# STERLING RANCH ROAD & BRIARGATE PARKWAY GESC

## COUNTY OF EL PASO, STATE OF COLORADO GRADING AND EROSION CONTROL PLANS DECEMBER 2021

EPC STORMWATER REVIEW COMMENTS  
IN ORANGE BOXES WITH BLACK TEXT

STERLING RANCH ROAD &  
BRIARGATE PARKWAY GESC  
GRADING AND EROSION  
CONTROL PLANS  
SHEET 3 OF 9  
JOB NO. 25188.03

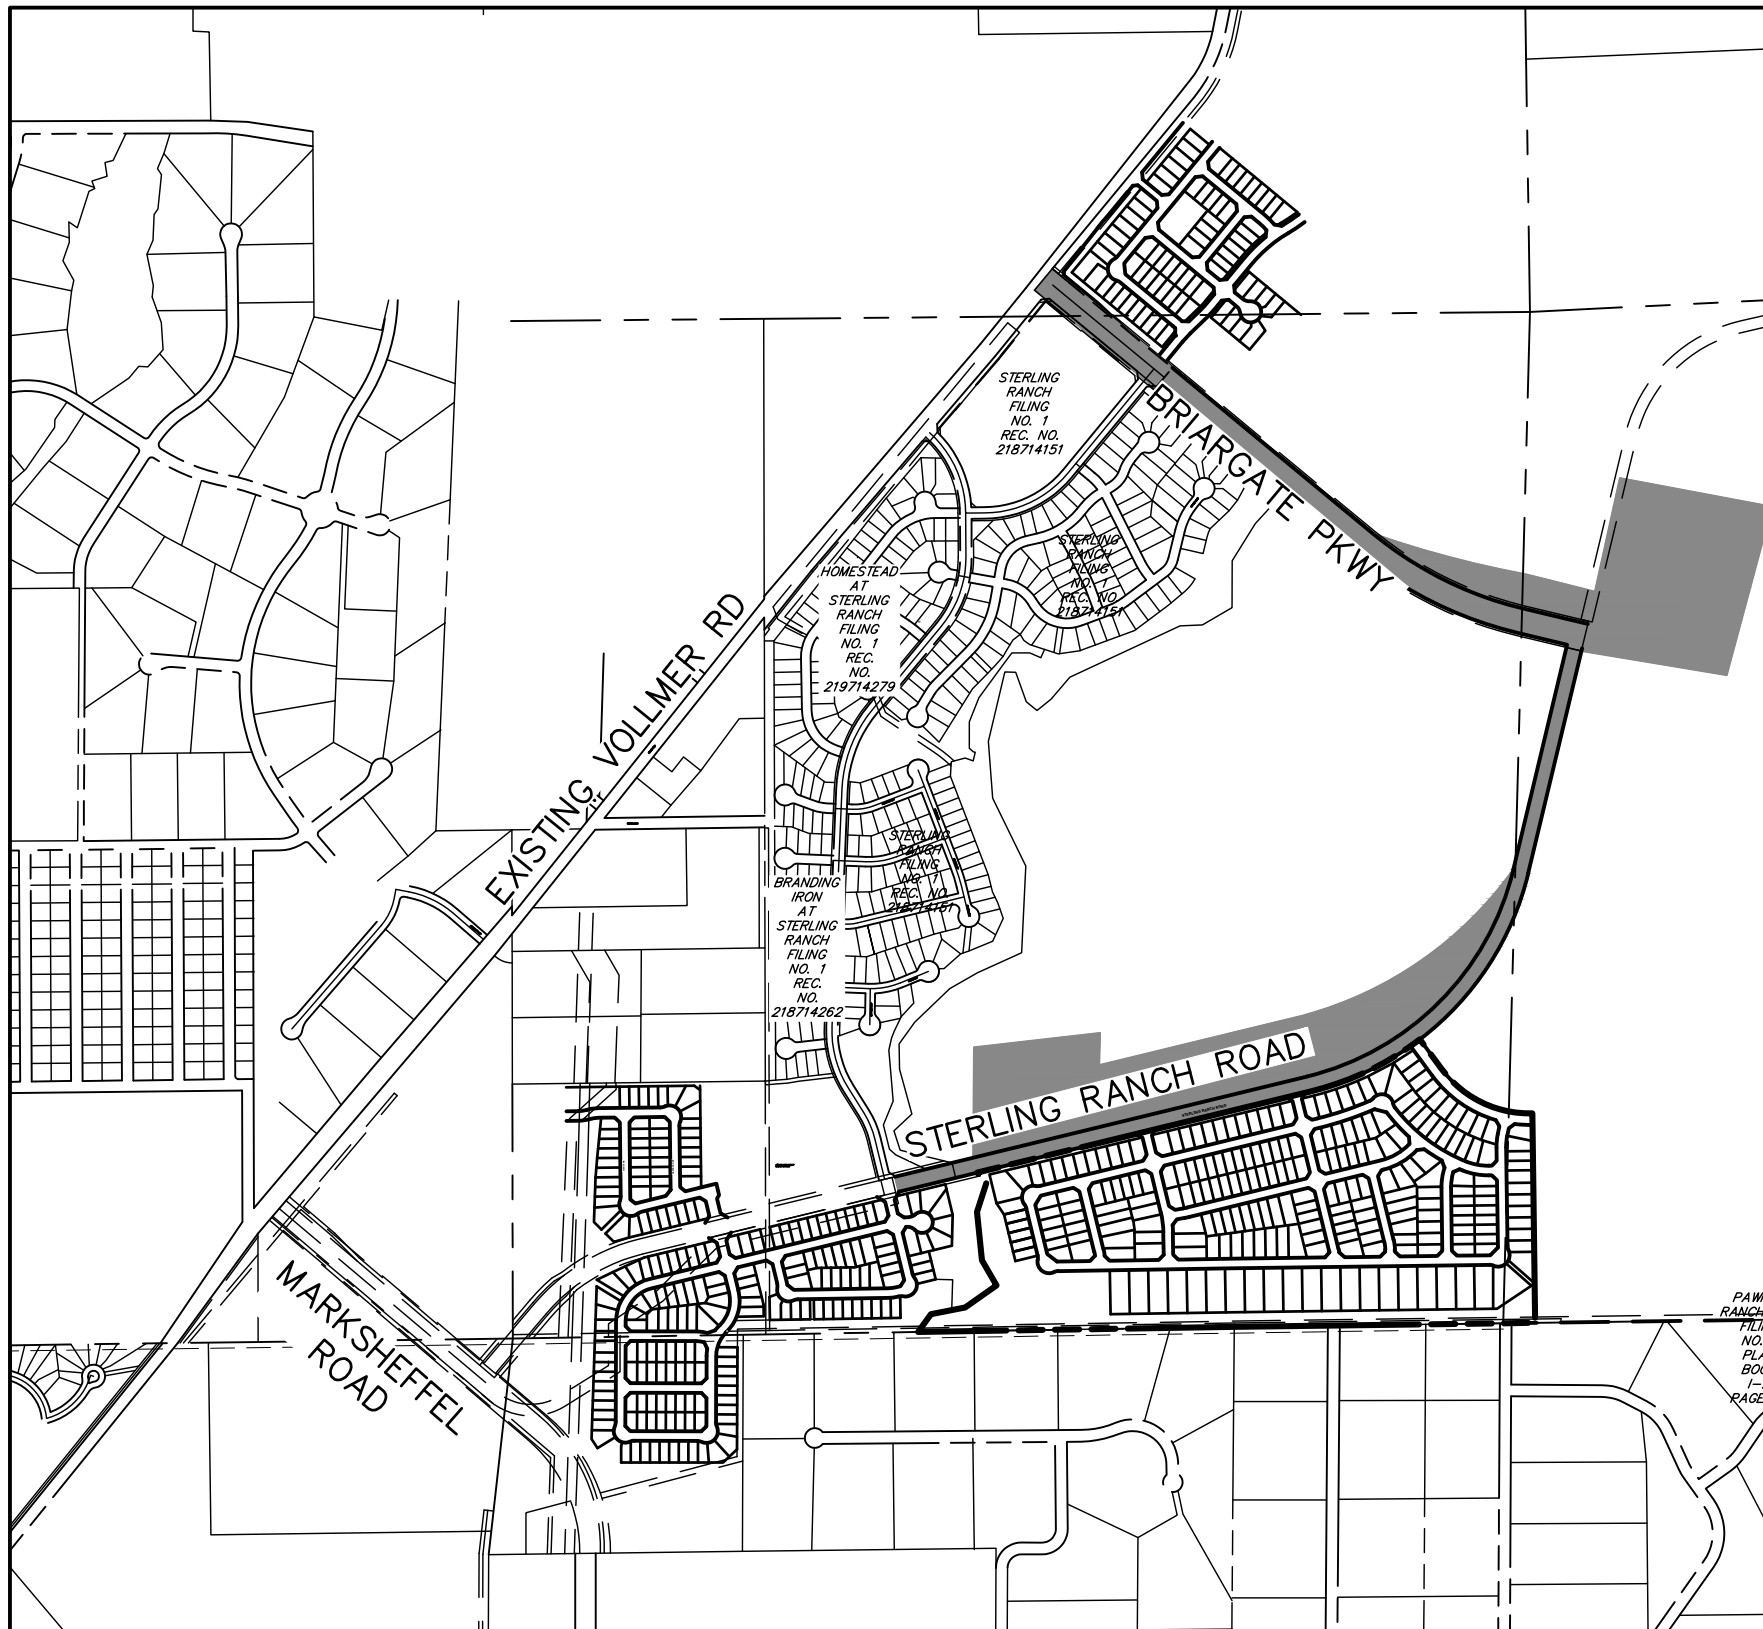
Add CDR-22-001

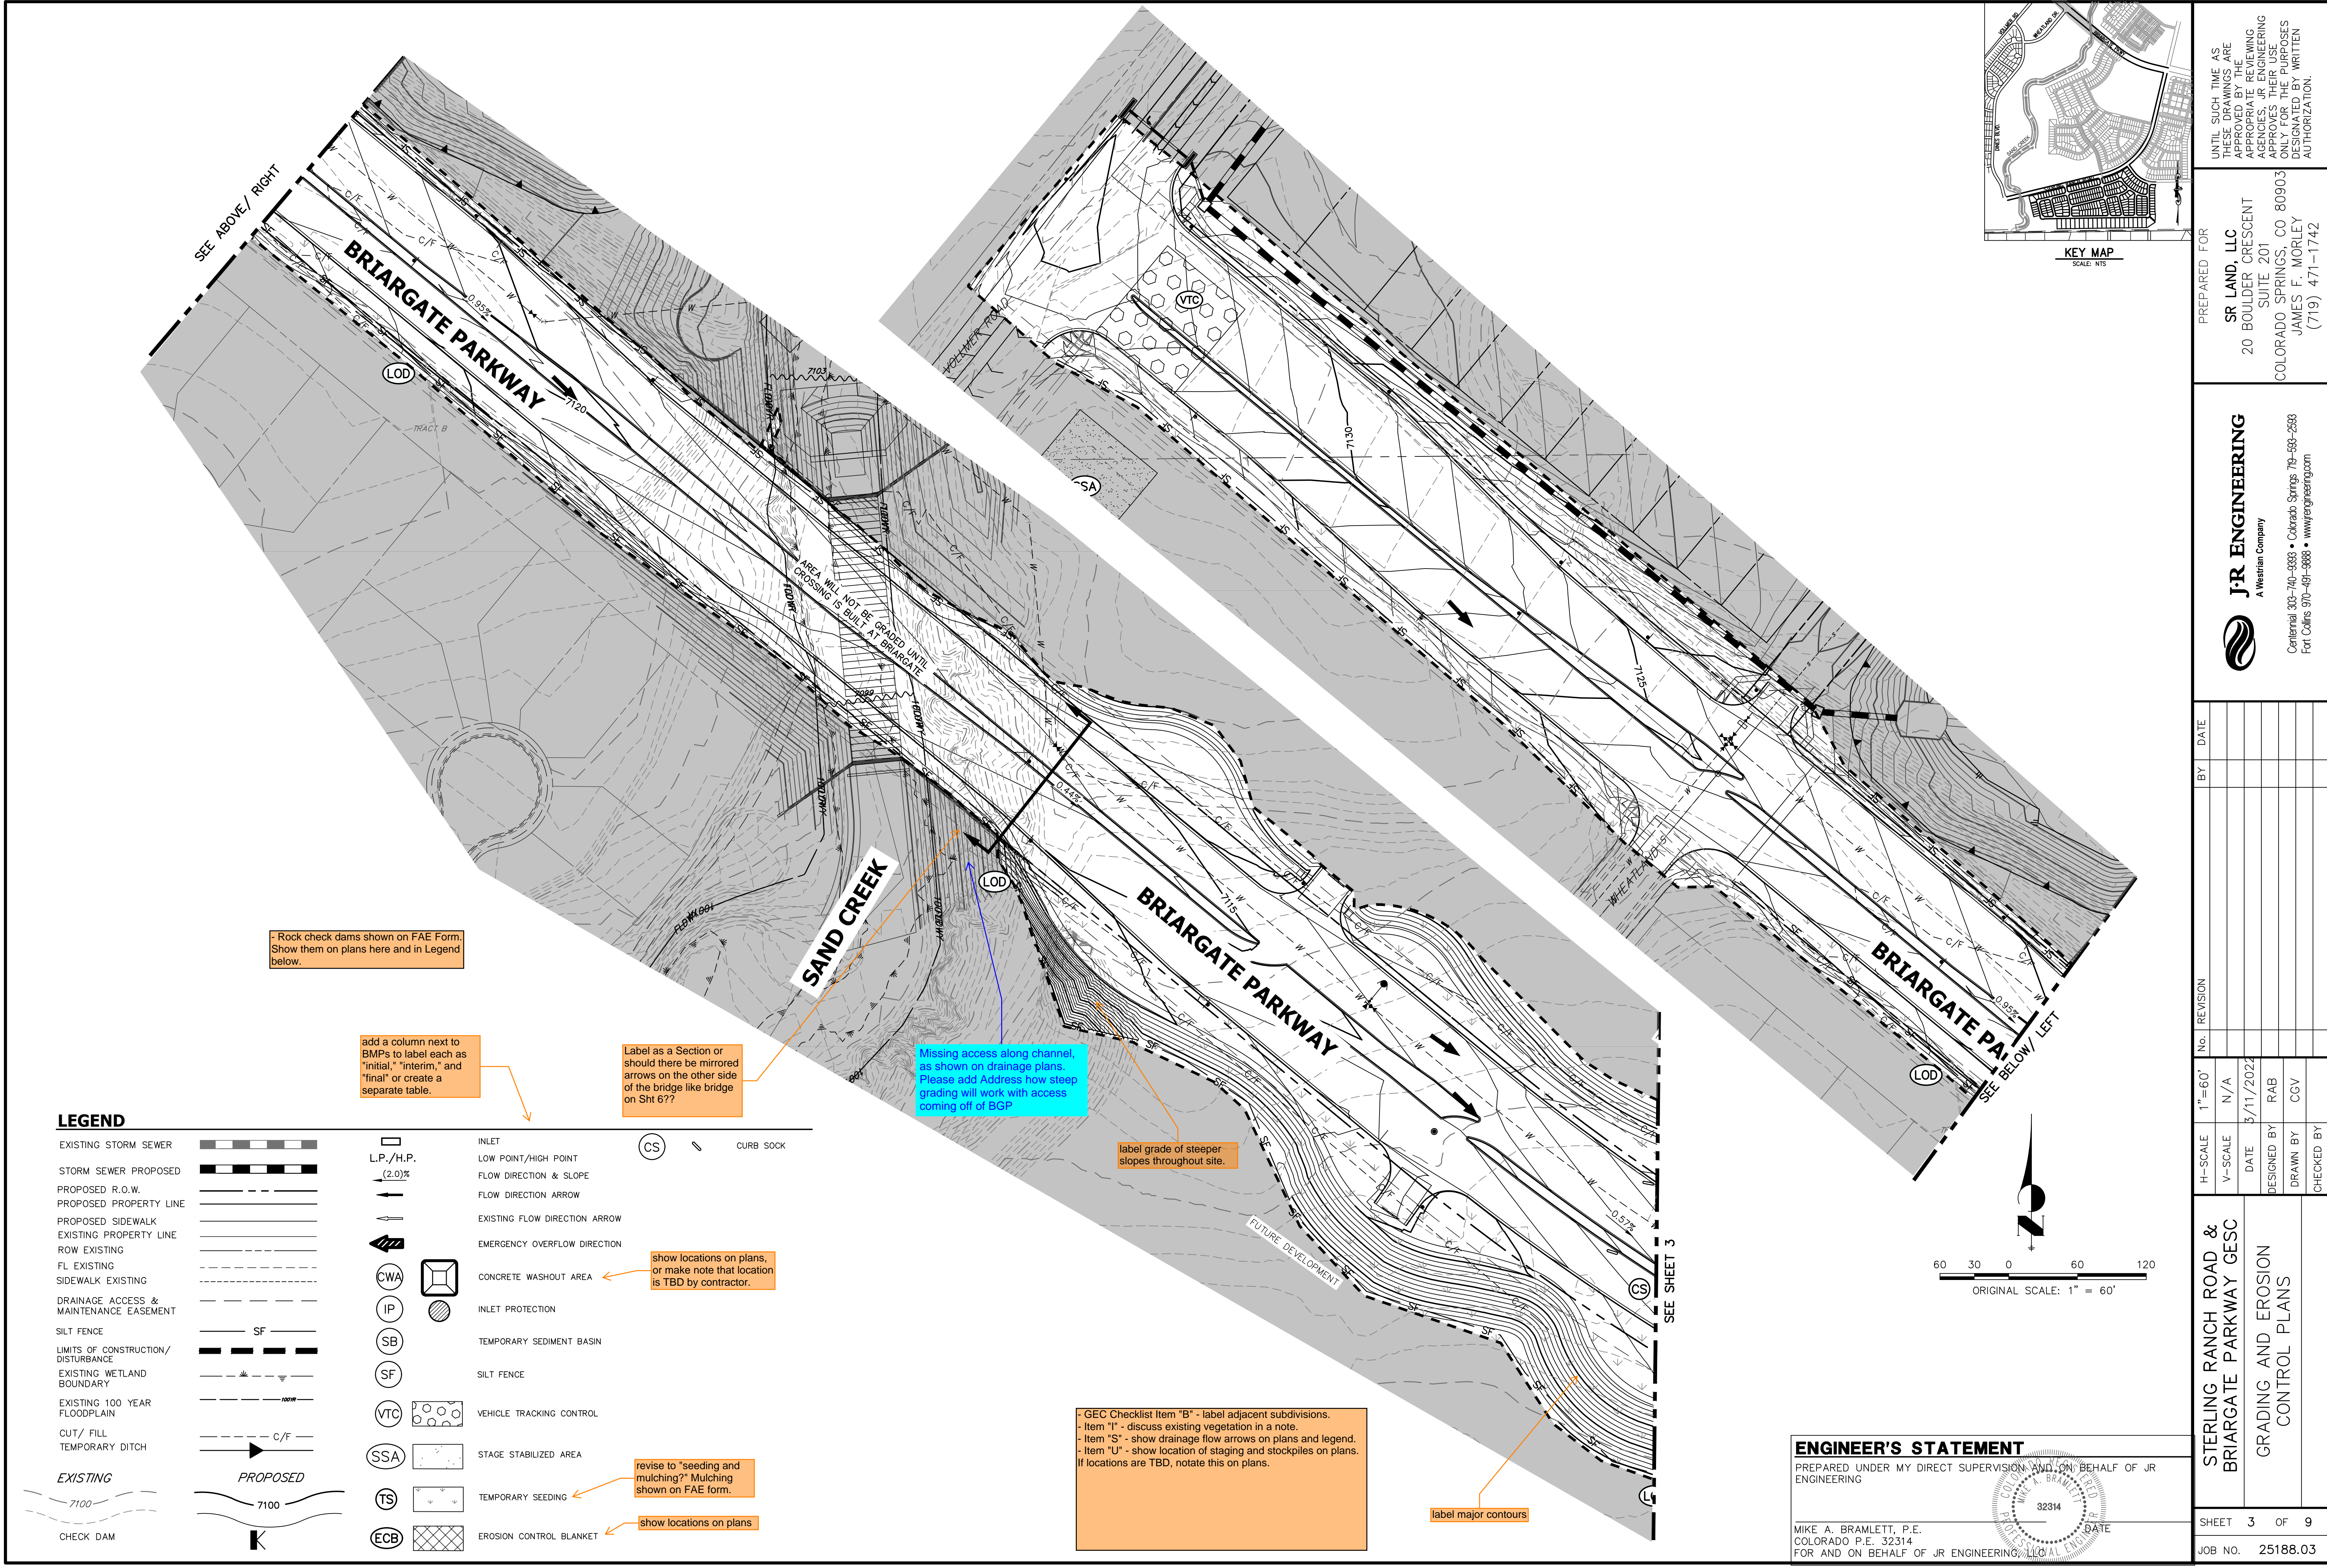
label and provide detailed info for TSB and EDB (forebay(s), trickle channel, maintenance access road, etc).

label major contours

Show erosion protection on spillway.

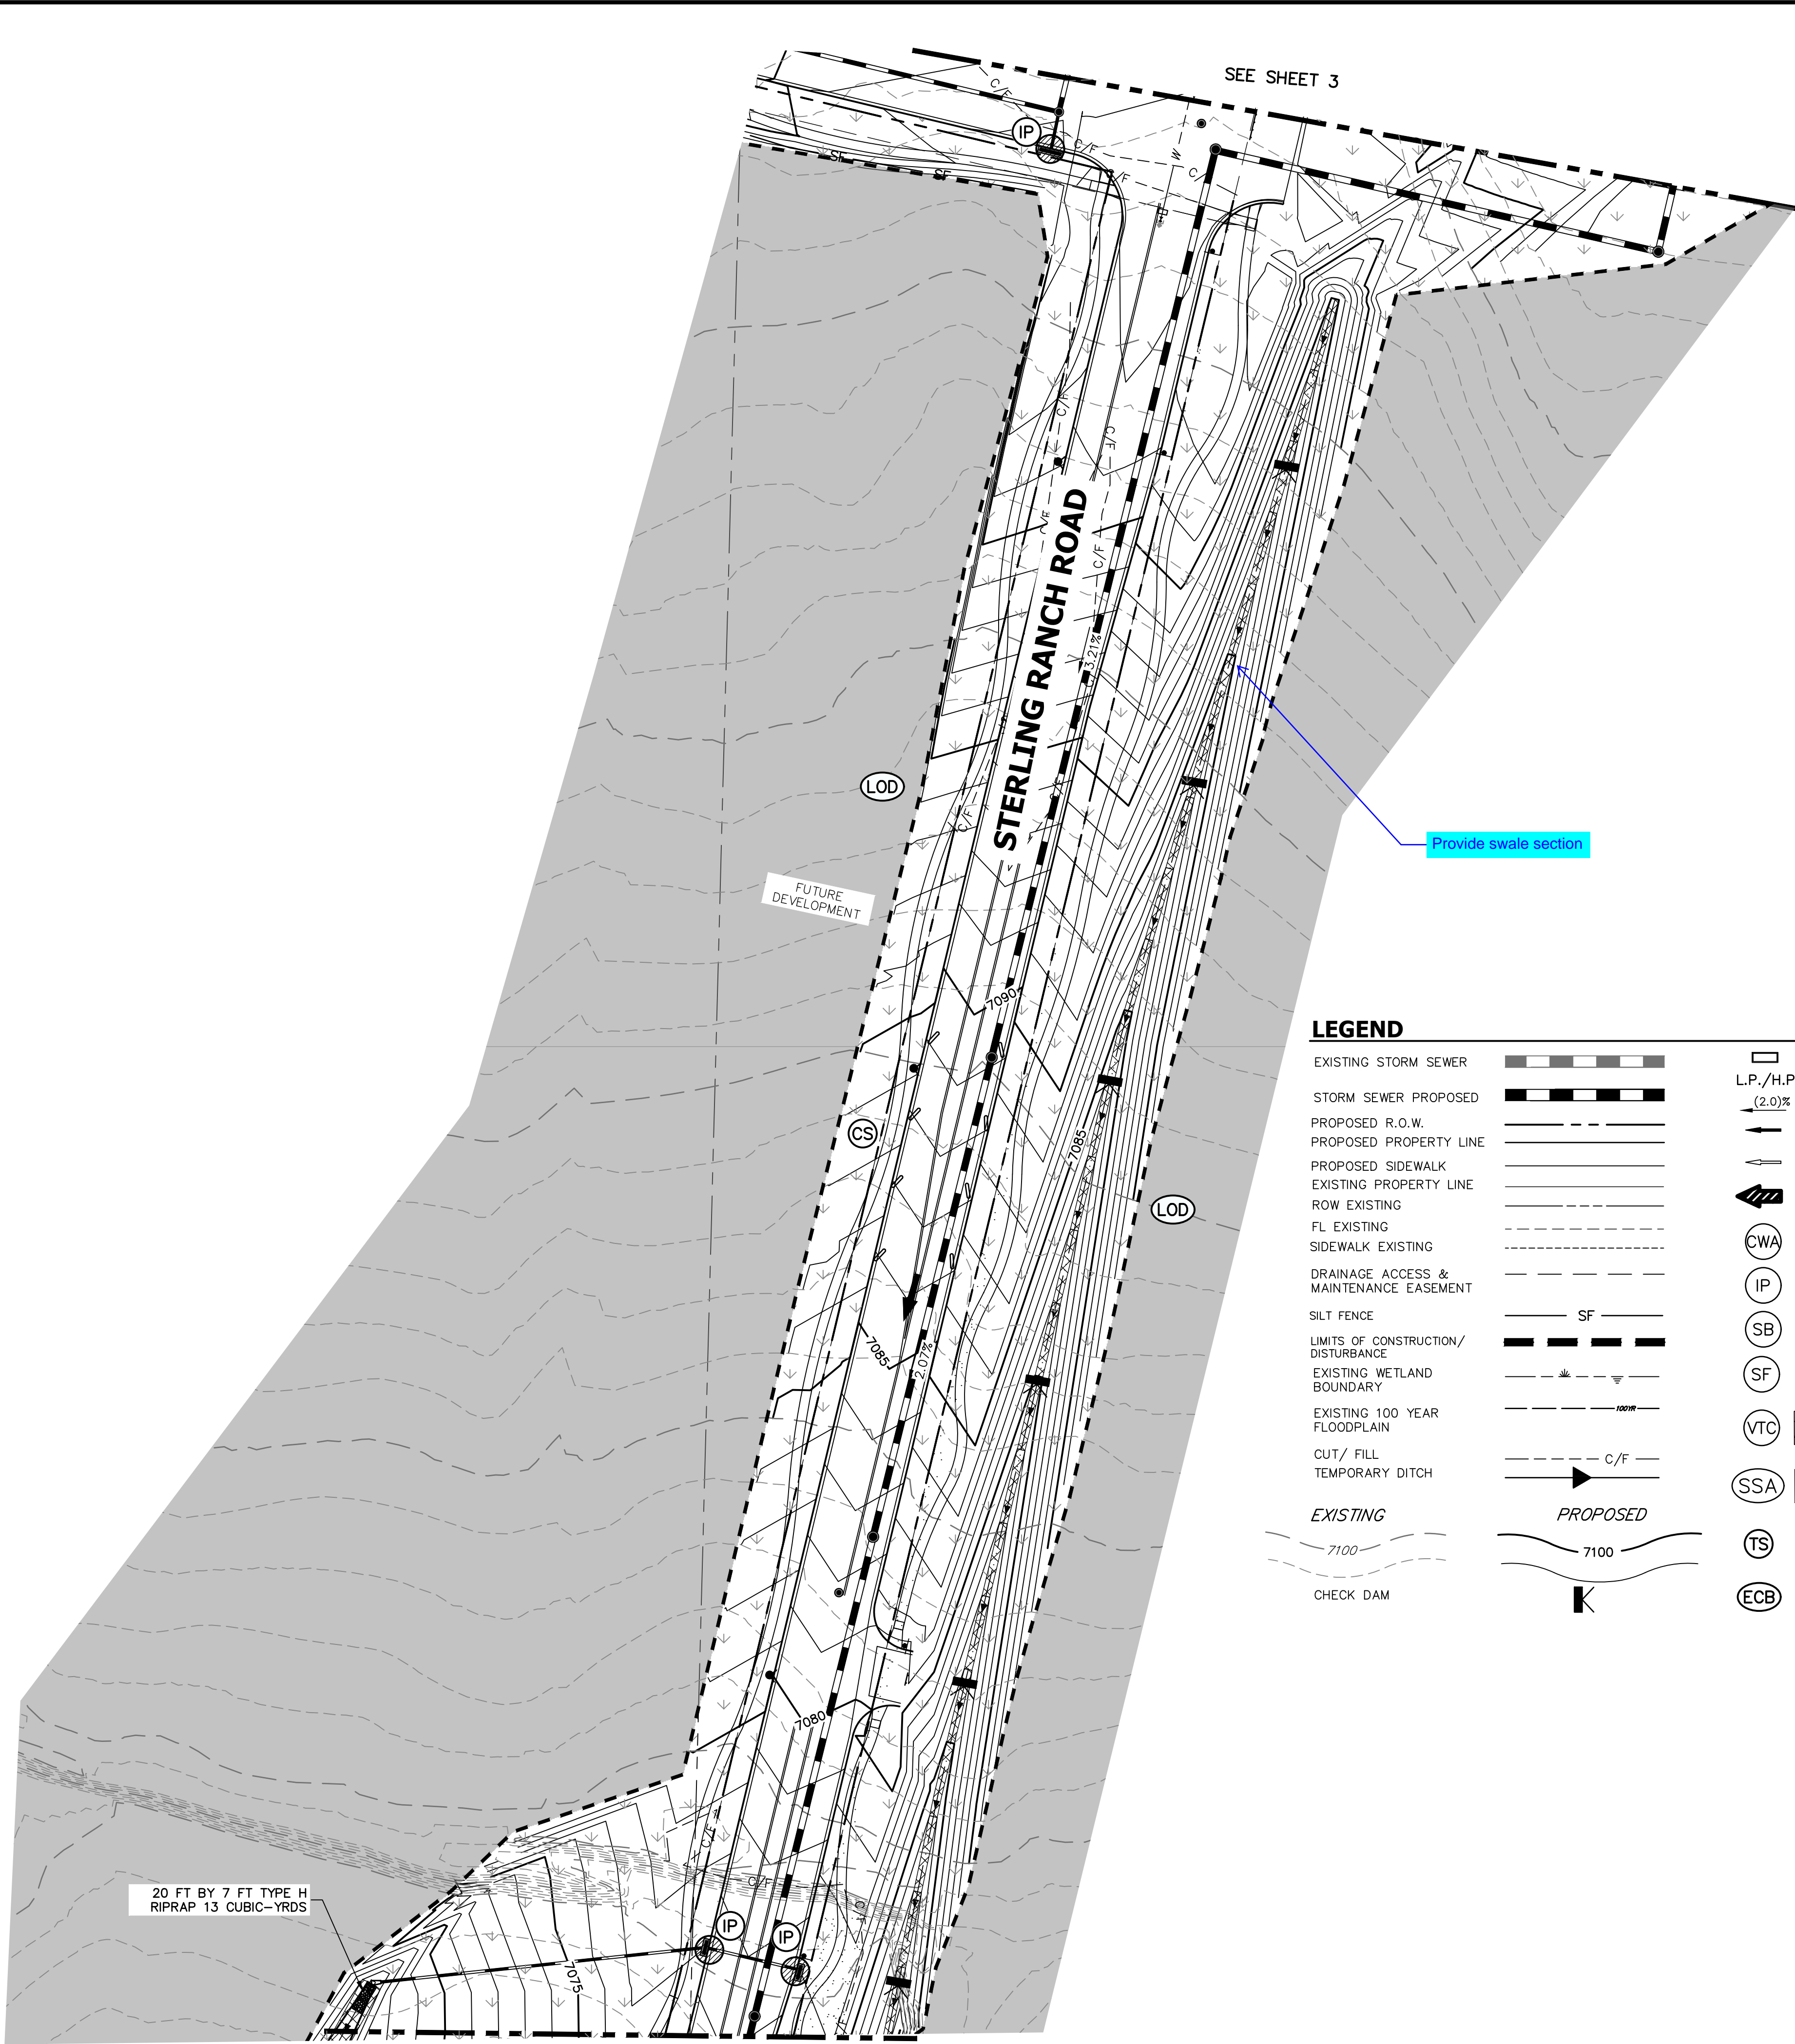
- Rock check dams shown on FAE Form. Show them on plans here and in Legend below.

add a column next to BMPs to label each as "initial," "interim," and "final" or create a separate table.

Label as a Section or should there be mirrored arrows on the other side of the bridge like bridge on Sht 6??

Missing access along channel, as shown on drainage plans. Please add Address how steep grading will work with access coming off of BGP

label grade of steeper slopes throughout site.

show locations on plans, or make note that location is TBD by contractor.

revise to "seeding and mulching?" Mulching shown on FAE form.

show locations on plans

- GEC Checklist Item "B" - label adjacent subdivisions.  
- Item "I" - discuss existing vegetation in a note.  
- Item "S" - show drainage flow arrows on plans and legend.  
- Item "U" - show location of staging and stockpiles on plans.  
If locations are TBD, notate this on plans.

label major contours
